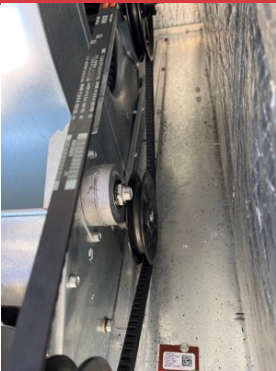
Condensate lines have not been completely installed
